EQUIPMENT AFFECTED
RC700
 RC721, RC722/KBU 723, KBU 722, KBU 721
 Keyboard

REASON FOR CHANGE

FIELD CHANGE ORDER

NO. 19-007

Modification RC 721

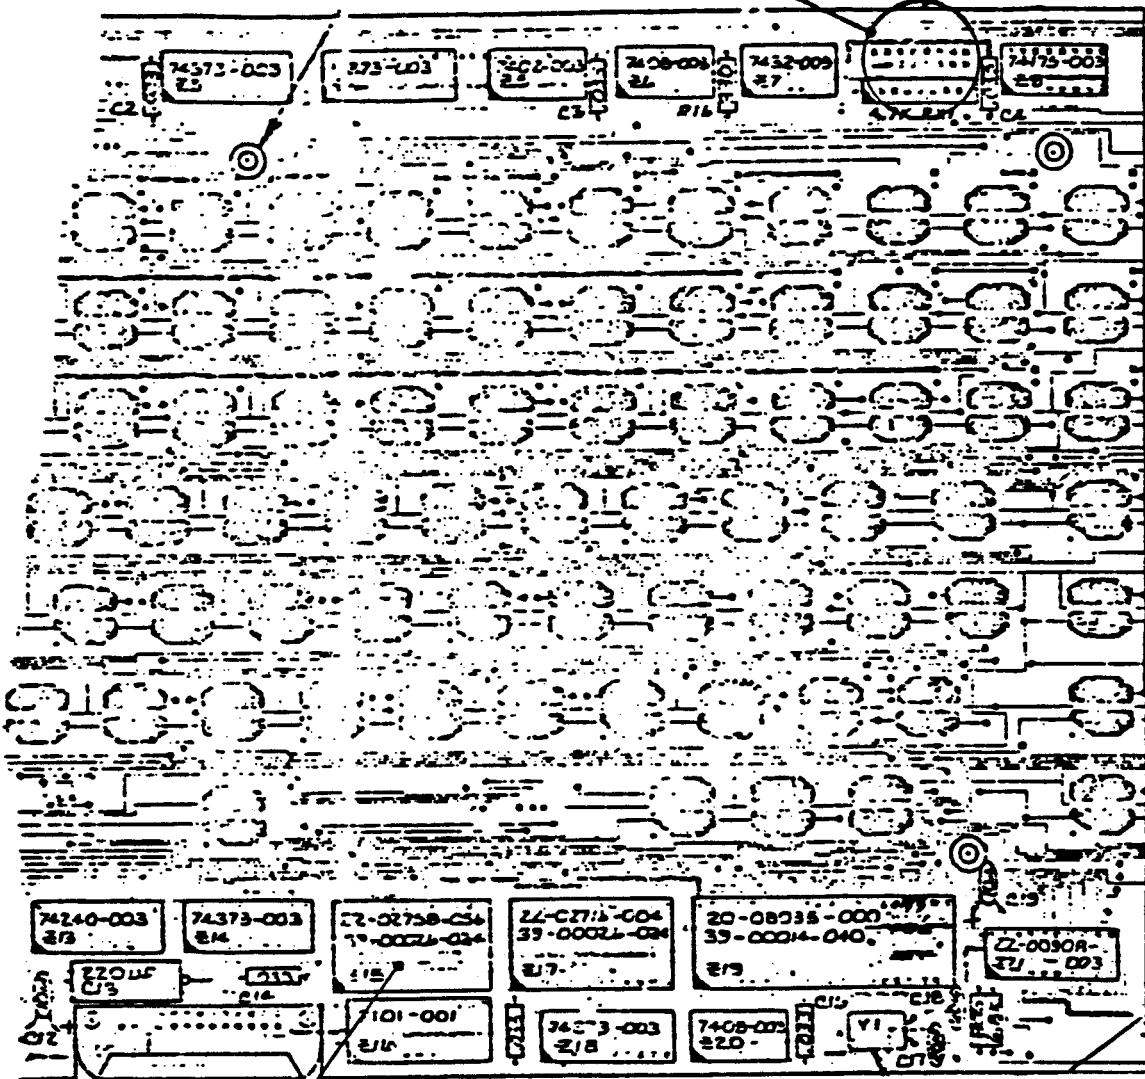
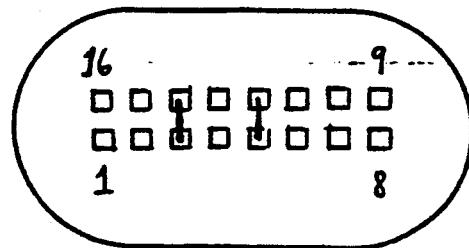
Connect pin 3 to 14
and pin 5 to 12
as shown.

Insert 22 pF under metal cover as shown

Insert ROA 434 in empty socket

Pin 1-16 already installed
Pin 3-14 new capacitor

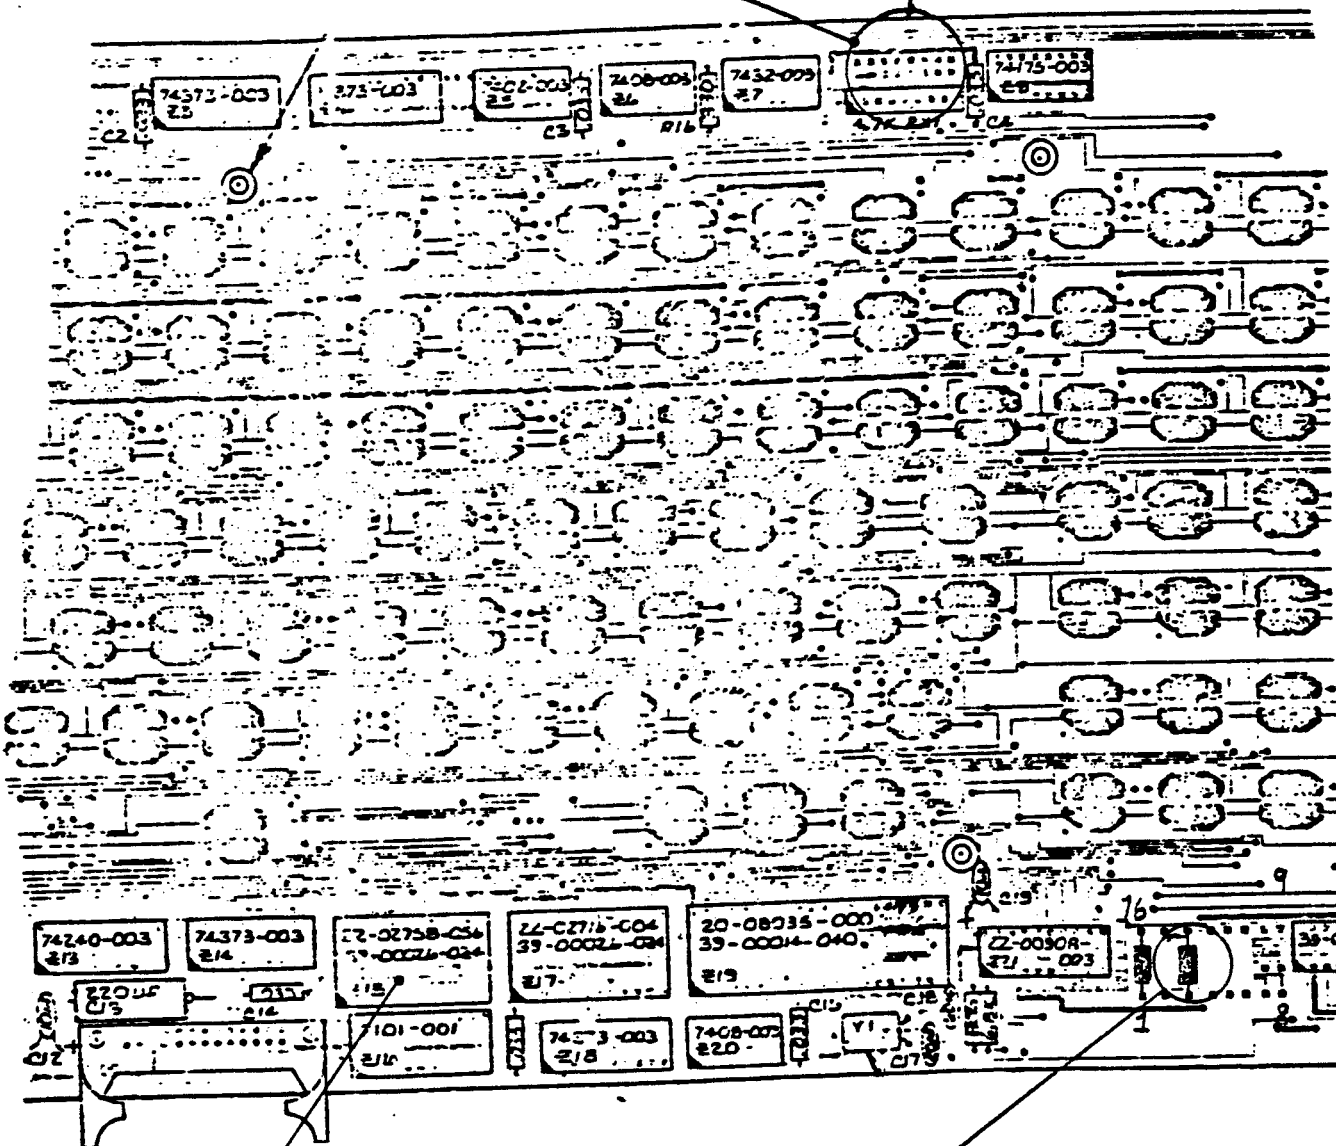
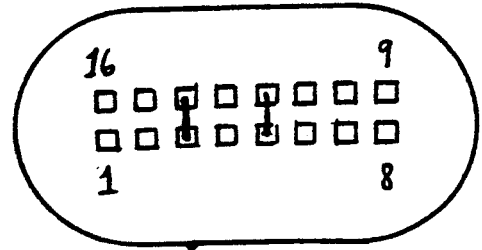
Connect pin 3 to 14
and pin 5 to 12
as shown.

Insert ROA 434
in empty socket

Insert 22PF pin 3
to pin 14
